PMRE-Iditarod Dog Sledding Historic District Workshop Summary and Implementation Plan

***Port MacKenzie Rail Extension Project
Iditarod Dog Sledding Historic District Workshop Summary
and Implementation Plan***

Figure 3: Constraints

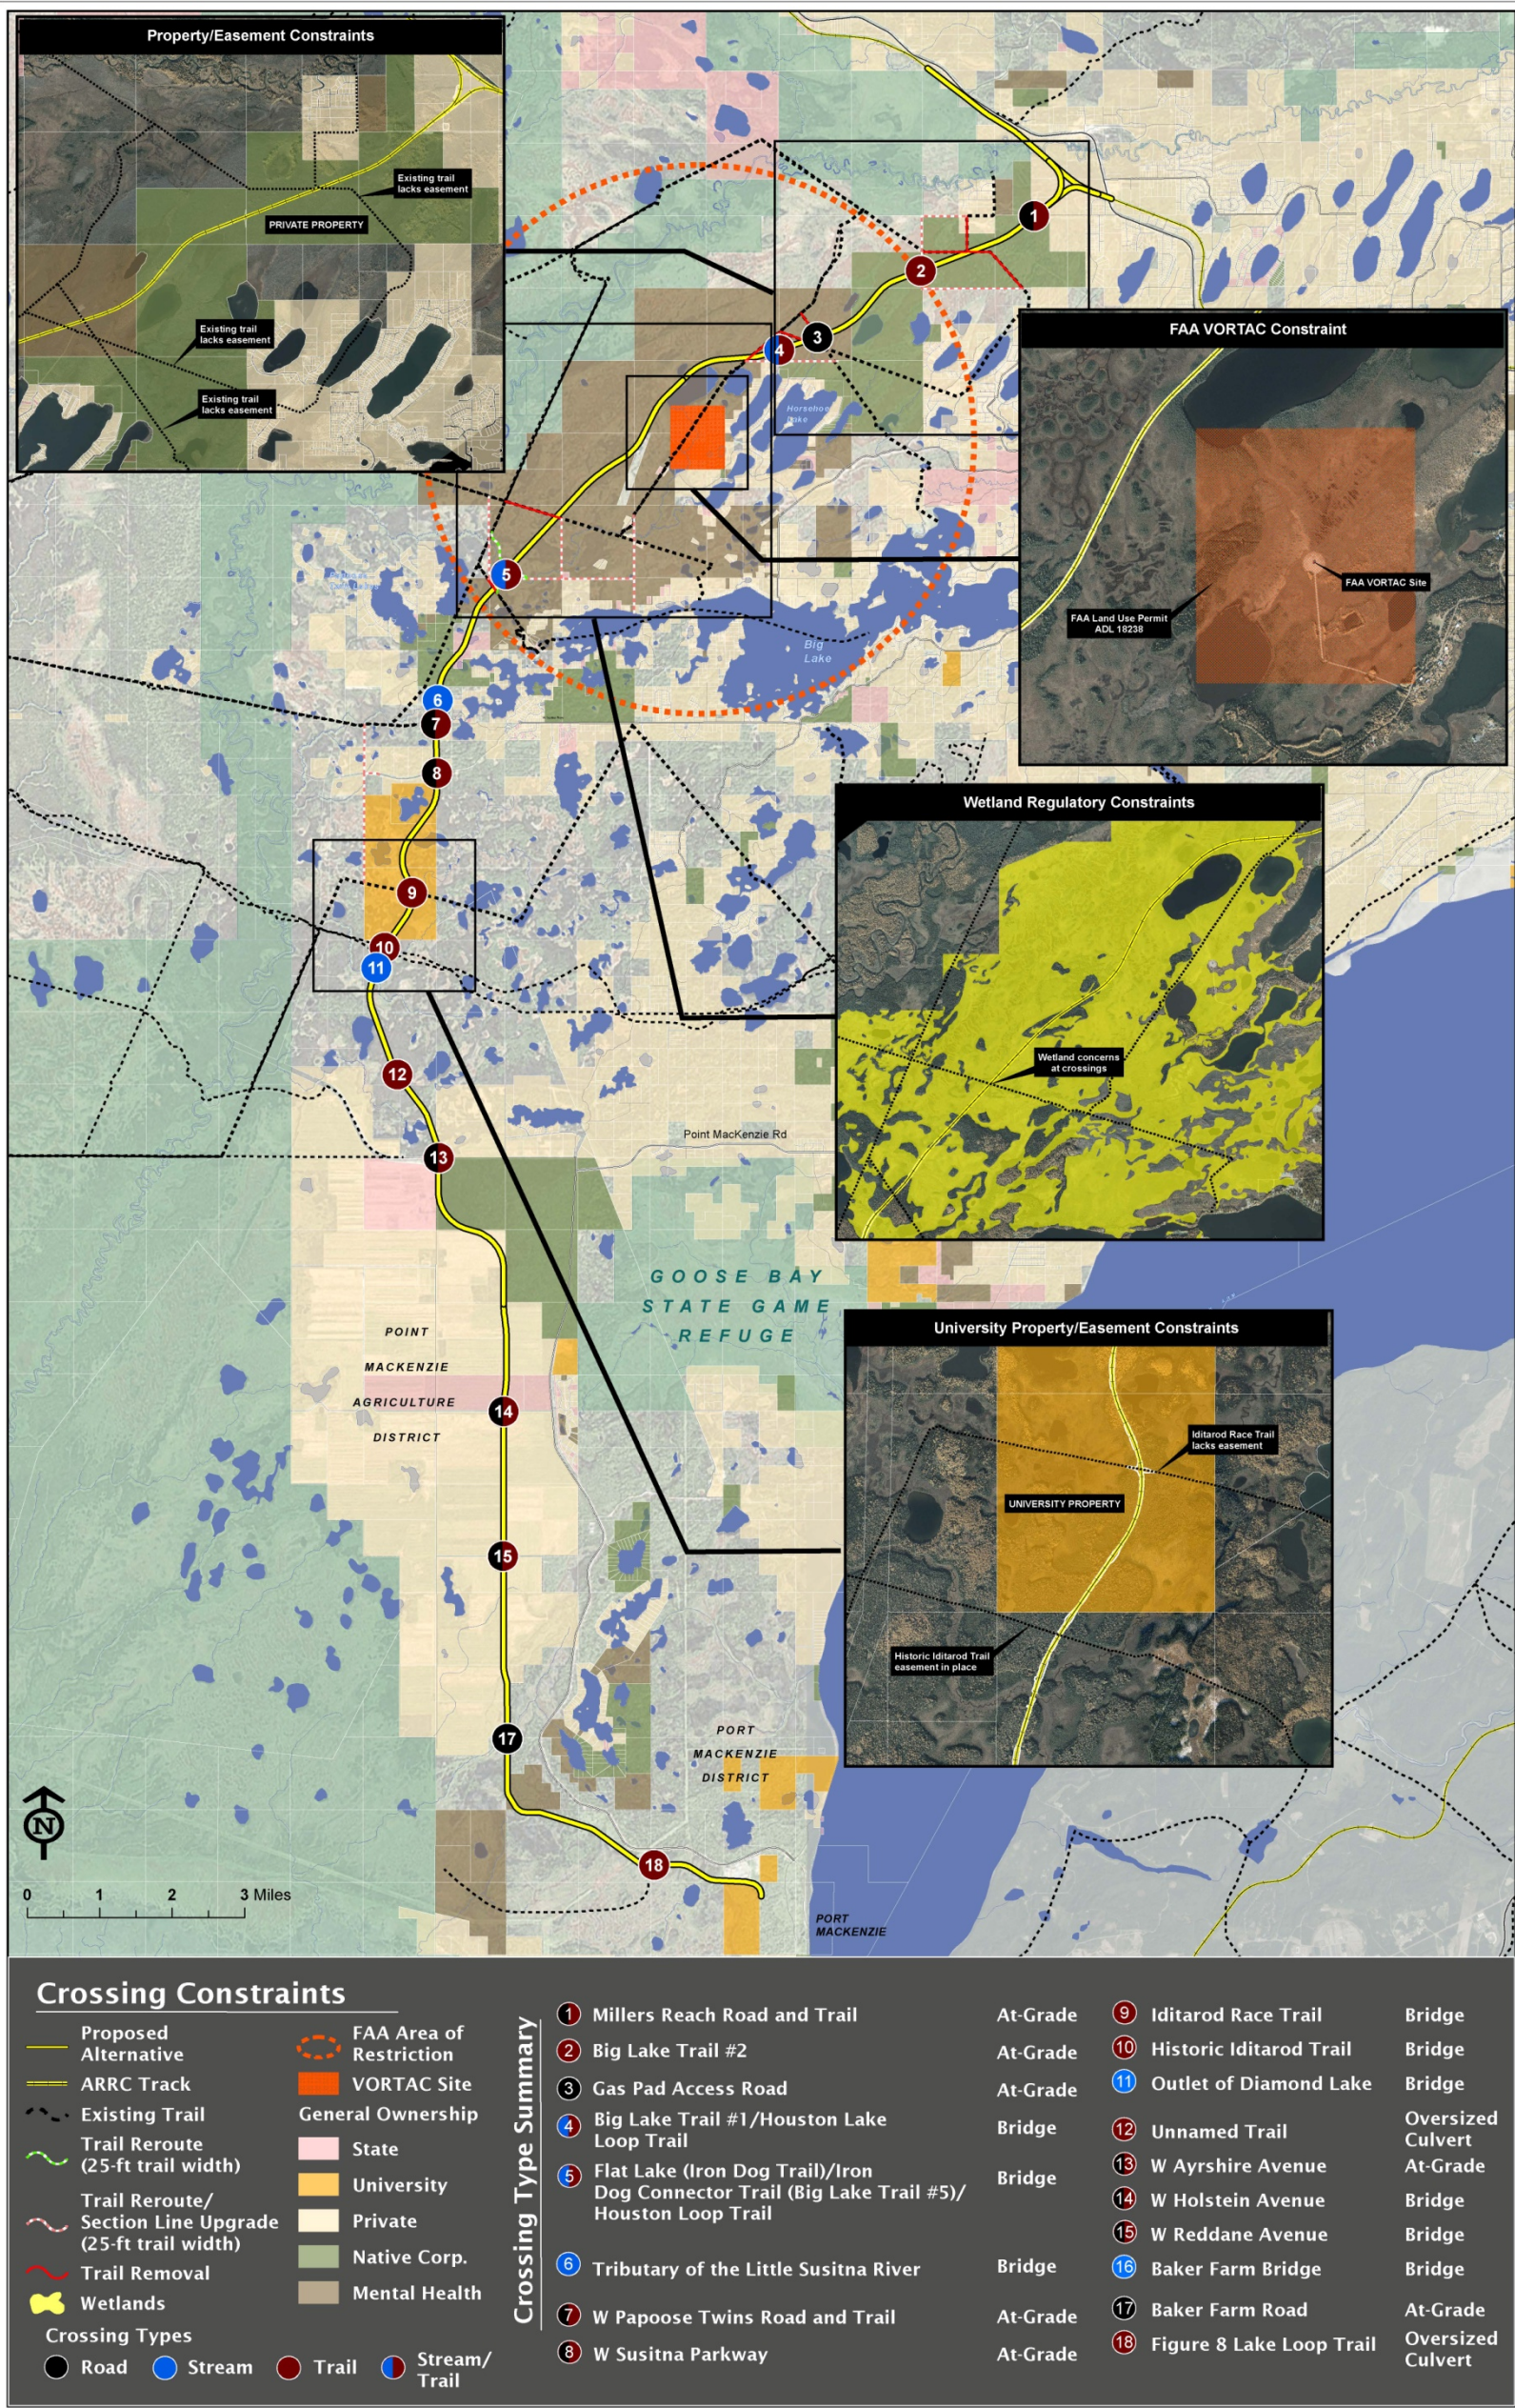
6	Provide participants with constraints map illustrating where crossings cannot be located	NA – Resolved. A constraints map was presented at the MSB Open House (Attachment F) and IDSHD Workshop 3 (Attachment G). The map was posted on the project website (http://www.portmacrail.com/maps/Constraints_v2%20web.jpg) and is included in Attachment A (Figure 3).	No further implementation needed.
7	Add crossings between Crossings 2 and 10 to maintain connectivity	The Project Team will continue efforts to identify additional crossings between Crossings 2 and 10. Constraints for crossings in this area include: safety concerns, regulatory issues, design issues, property ownership, and property/easement constraints.	The Project Team is working with landowners, agencies, and trail users to identify additional crossings in the project area between Crossings 2 and 10.
8 and 9	Provide crossing for the Iron Dog Connector Trail and the Flat Lake Connector Trail	The project will include a crossing and reroute for the Iron Dog Connector Trail and the Flat Lake Connector Trail (Crossing 5).	The Project Team/MSB is working with MHLT to acquire trail reroute easements (Exhibit 4). If MHLT does not grant an easement for the reroute, the Project Team will notify workshop participants and provide a revised proposal for continued access and connectivity.

Multiple constraints (see Attachment A, Figure 3) have affected project design including development of avoidance, minimization, or mitigation measures:

Wetland complexes between Crossings 4 and 6 have restricted the locations of crossings (see Attachment A, Figure 3). In consultation with the Project Team, the Corps and EPA requested that there be no increases in the project footprint in wetlands areas to accommodate a widened embankment area. As a result, the Project Team has worked to keep the rail embankment as low as possible to minimize impact in wetlands areas. In the case of the Iron Dog Connector Trail (an officially recognized trail), adding a grade-separated crossing would require raising the embankment high enough to provide 12' to 14' of clearance for trail users and would increase the fill footprint of the embankment over several miles. Adding an at-grade crossing would increase the impact to wetlands as the crossing would require additional embankment at the approaches to the proposed railroad crossing.
